New England Highway bypass of Singleton

Addendum review of environmental
factors

August 2024

Figure 1-2: Southern connection

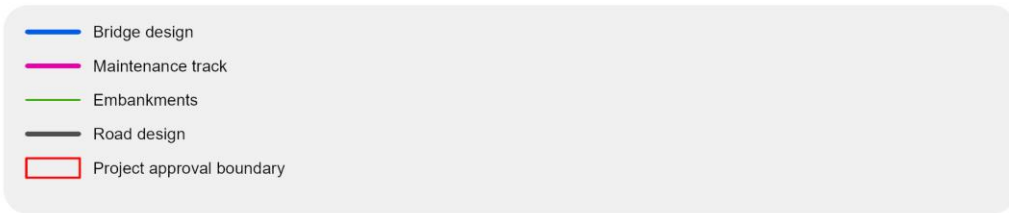
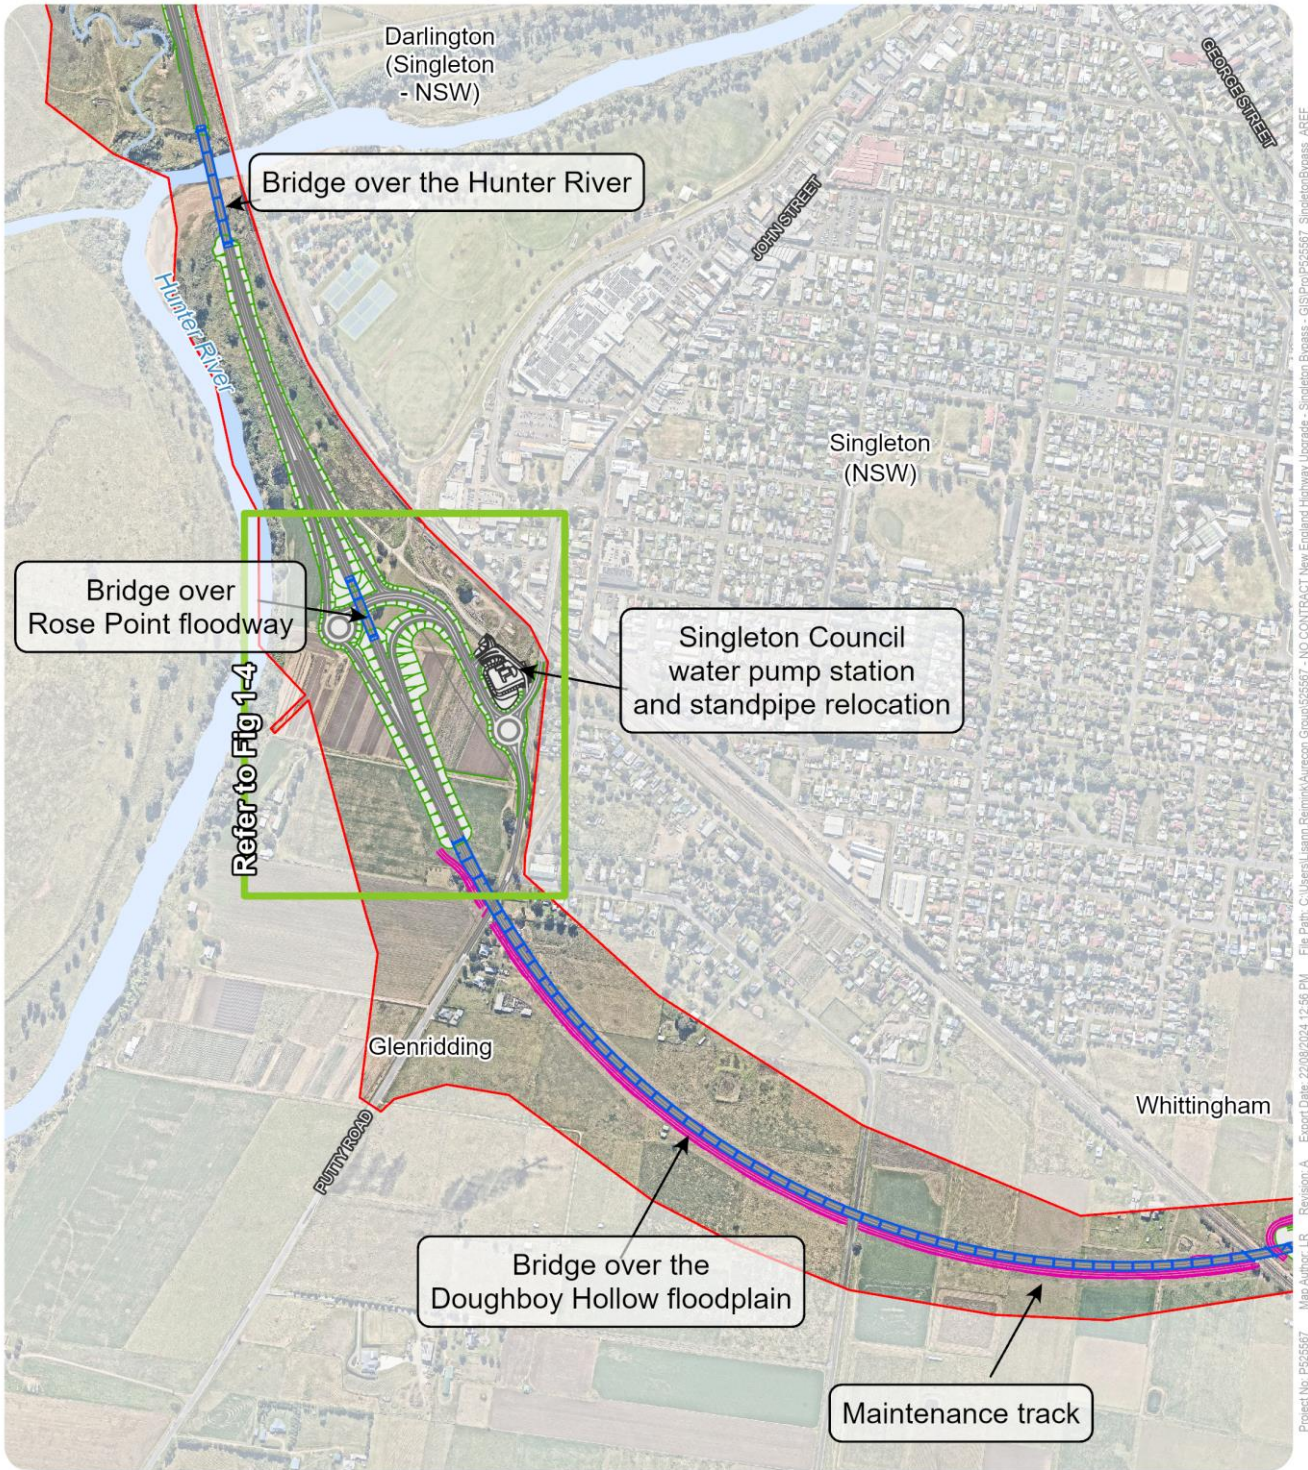
The southern connection with the New England Highway at Whittingham as presented in the addendum REF (October 2023) has been reconfigured. The interchange arrangement has been revised to accommodate improved road geometry on the main alignment of the Project. The northbound exit ramp and southbound entry ramp have been lengthened to match a larger mainline curve, improving road safety. The access to properties on Newington Lane has been simplified with a single crossing between the entry and exit ramps replacing a turnaround bay and extra intersection on White Falls Lane.

Associated road furniture, drainage and earthworks, including landscaping would be completed. Extra material would be excavated from adjacent borrow sites to improve drainage and cut to fill haulage operations during construction of the Project. Locally excavating material from borrow sites would minimise impacts on the road network and improve environmental sustainability outcomes by using less fuel. The reconfiguration of the southern connection is shown on Figure 1-2.

Figure 1-3: Putty Road connection

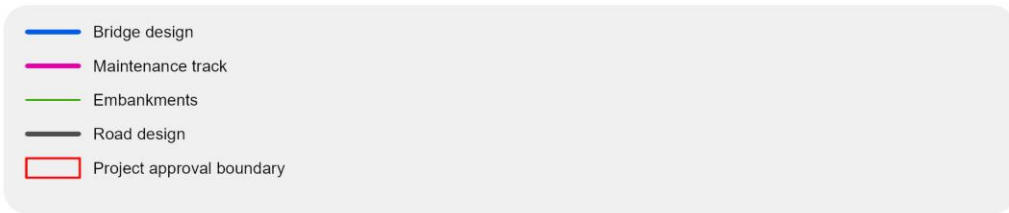
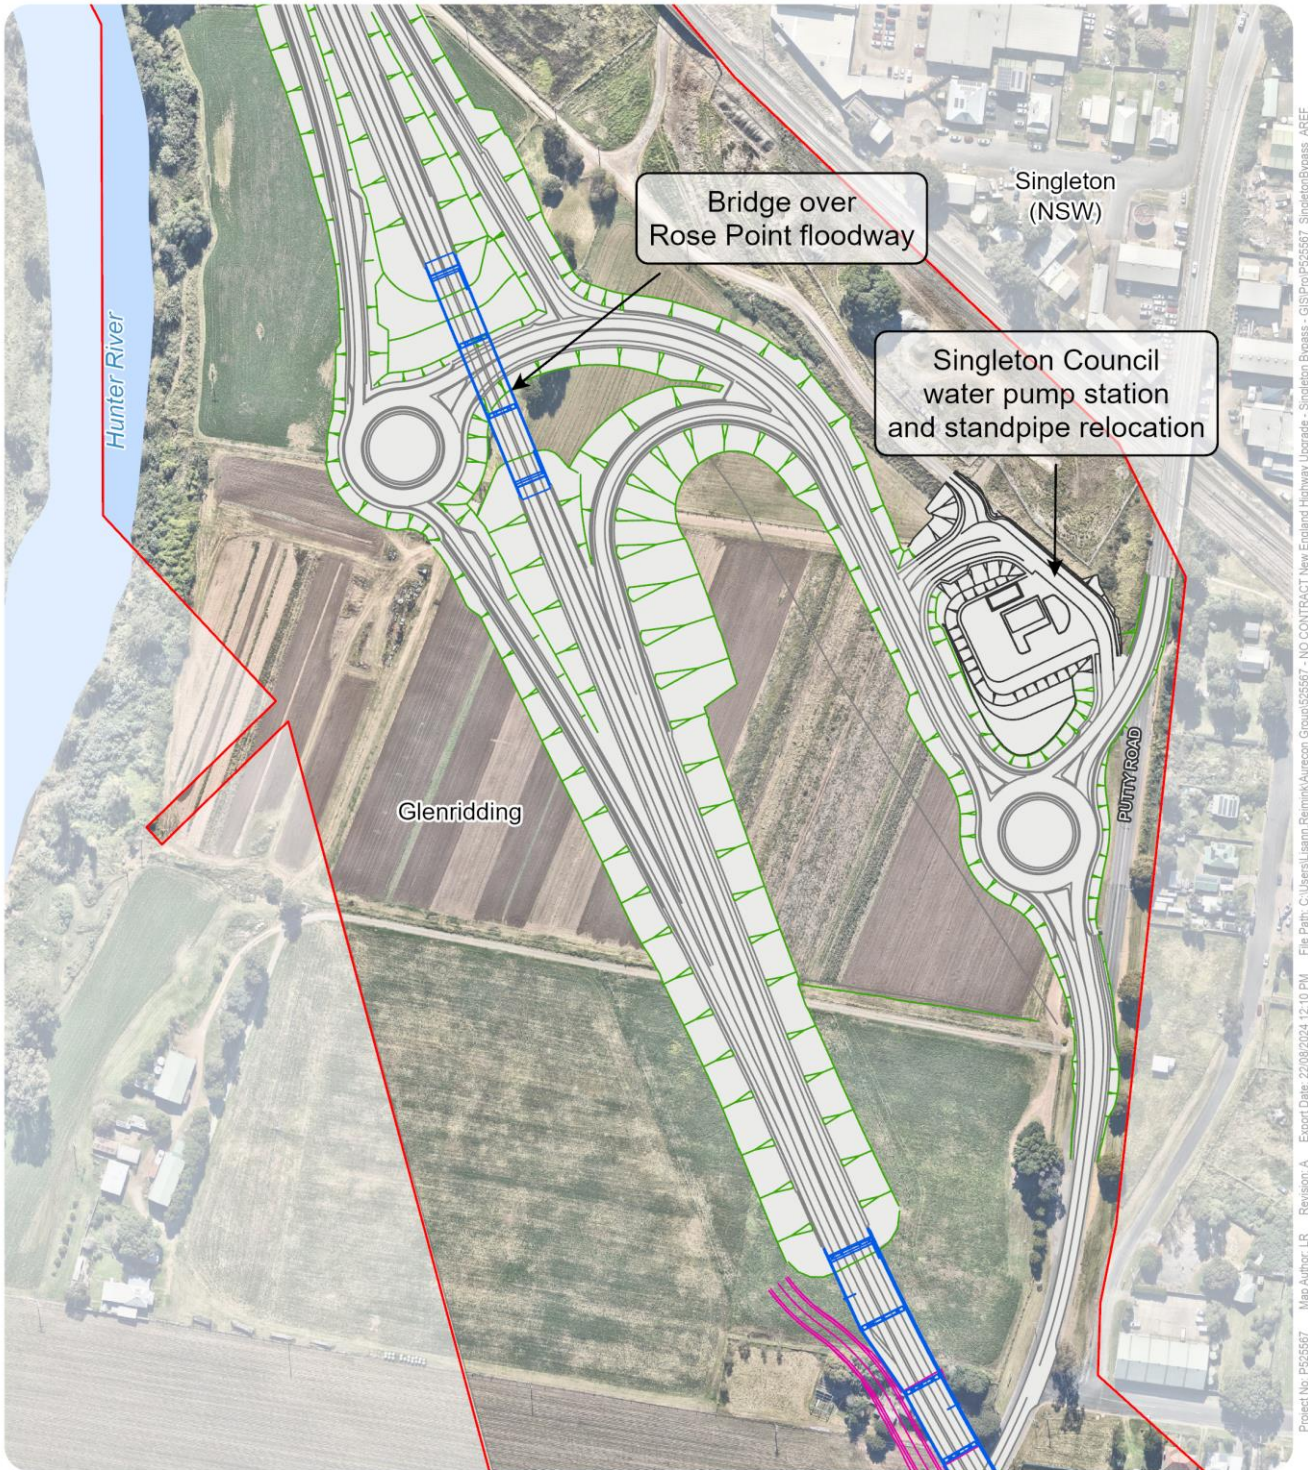
The design of the Putty Road connection as presented in the addendum REF (October 2023) is proposed to be modified. The Putty Road interchange has been realigned to improve safety, flood performance and maintenance. The northbound exit ramp arrangement is reconfigured to a conventional interchange arrangement for improved road safety, and the northbound entry and southbound exit flood immunity has been increased from 5 years to 10 years. The Putty Road roundabout has been shifted from Putty Road further north away from properties. The Putty Road Lane and shoulder arrangements have also been formalized with edge line marking for road safety and to define the shoulder in the road corridor.

Associated road furniture, drainage and earthworks, including landscaping have been adjusted to accommodate the above changes. Extra material would be excavated from adjacent borrow sites to improve drainage and cut to fill haulage operations during construction of the Project. Locally excavating material would reduce haulage from the north of the Project minimising impacts to the road network and improving environmental sustainability outcomes by using less fuel. The reconfiguration of the Putty Road connection is shown on Figure 1-3 and Figure 1-4. The Singleton Council water pump station and standpipe relocation is consistent with the addendum REF (October 2023).
